Conceptual Review Agenda

Schedule for 06/17/13 to 06/17/13

Re: 4312 S College - First Choice Emergency Room Medical Care Facility

Comment Summary:

GSP-1

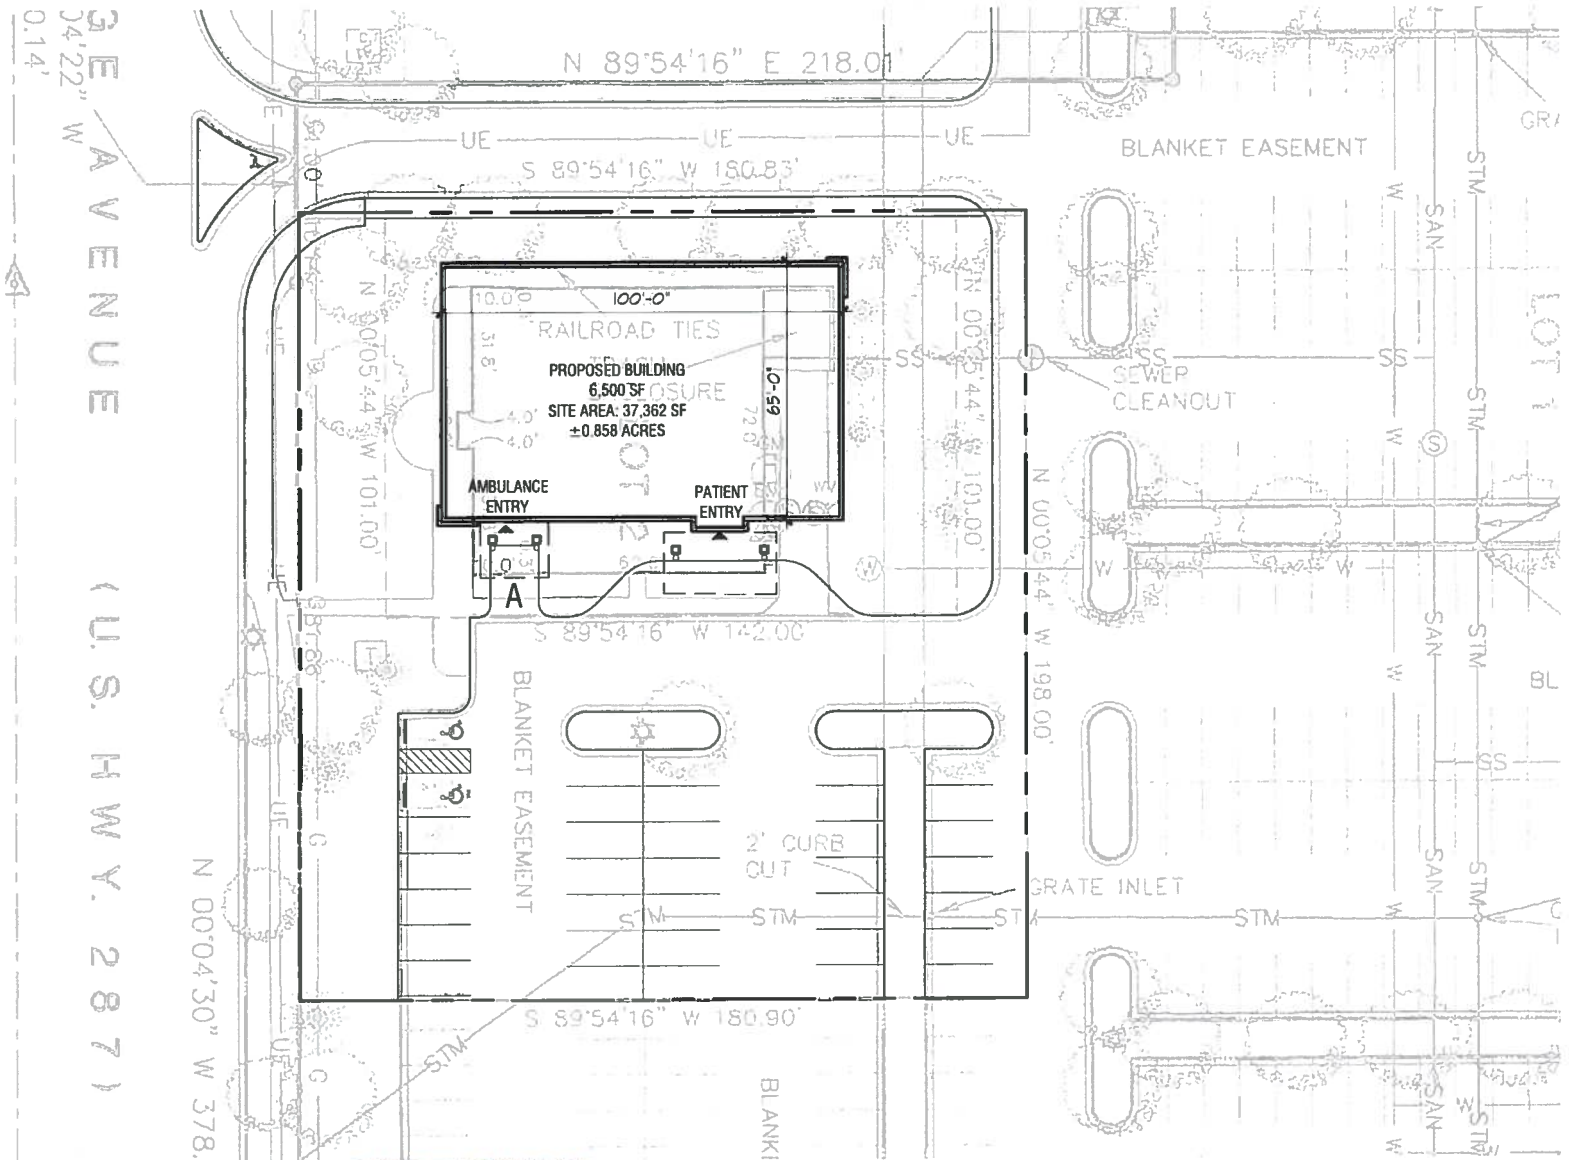
3. Onsite water quantity detention is provided in the parking lot as shown on the exhibit provided. Any disturbance within those areas will need to maintain the detention volume.

2. Every attempt must be made to preserve the existing trees. These trees have reached a level of maturity that they provide a valuable aesthetic for both the shopping center and South College Avenue. Please add the standard tree protection notes contained in Section 3.2.1(G) to the Landscape Plan.

3. The plans refer to covered patient entry feature. Please note that any under-canopy lighting must be specified to be "flush mount - flat lens" so that the light source is shielded in accordance with Section 3.2.4.
